Lindeman Great Barrier Reef Resort  
Project

RESPONSE TO PUBLIC  
NOTIFICATION COMMENTS

**Submission details and management: Lindeman Great Barrier Reef Resort project, Draft Environmental Impact Statement public consultation.**

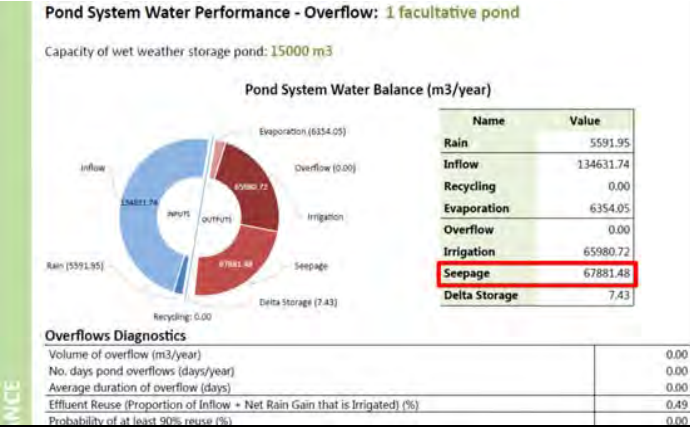
33.26	Noise and Vibration	Noise impacts on national parks	The noise impact assessment does not adequately address noise impacts on surrounding national parks during the construction or operation stages of the proposed project.  The EHP Planning for Noise Control guideline Table 1 identifies recommended outdoor background noise planning levels for recreation areas: <a href="https://www.ehp.qld.gov.au/assets/documents/regulation/ts-gl-planning-for-noise-control.pdf">https://www.ehp.qld.gov.au/assets/documents/regulation/ts-gl-planning-for-noise-control.pdf</a>	It is recommended that a revised draft EIS noise impact assessment be completed to fully assess the potential noise impacts on nearby National Parks and recreational areas which includes, but is not limited to: <ul style="list-style-type: none"> <li>• aircraft</li> <li>• helicopters</li> <li>• ERA's</li> <li>• vessels.</li> </ul> The EHP Planning for Noise Control guideline Table 1 identifies recommended outdoor background noise planning levels for recreation areas: <a href="https://www.ehp.qld.gov.au/assets/documents/regulation/ts-gl-planning-for-noise-control.pdf">https://www.ehp.qld.gov.au/assets/documents/regulation/ts-gl-planning-for-noise-control.pdf</a>	Chapter 16, Noise and Vibration, Section 16.4.1, Construction Noise Catchment Areas page 11 & 12	Proponent to respond	Noise also addressed in QLD Health submission (#19).  With respect to the ERAs, please see comment 33.22. This will require assessment once this information is known and could be conditioned to ensure it complies with whether planning for noise control guideline or the EPP acoustic quality objectives.  With respect to helicopters, aircraft and vessels it is unclear how the "Planning For Noise Control" guideline recommended hourly LA90 noise criteria relates to short terms events such as occasional aircraft flyovers or helicopter landings or vessels docking. This guideline is generally used for assessment of continuous noise such as plant and equipment adding to the existing background noise level

in an area. There may only be one or two of these short term events in an hour, so when this is averaged over an hour the existing background noise level is unlikely to be affected at all. Also there does not appear to be any specific criteria in the document for recreation areas as advised.
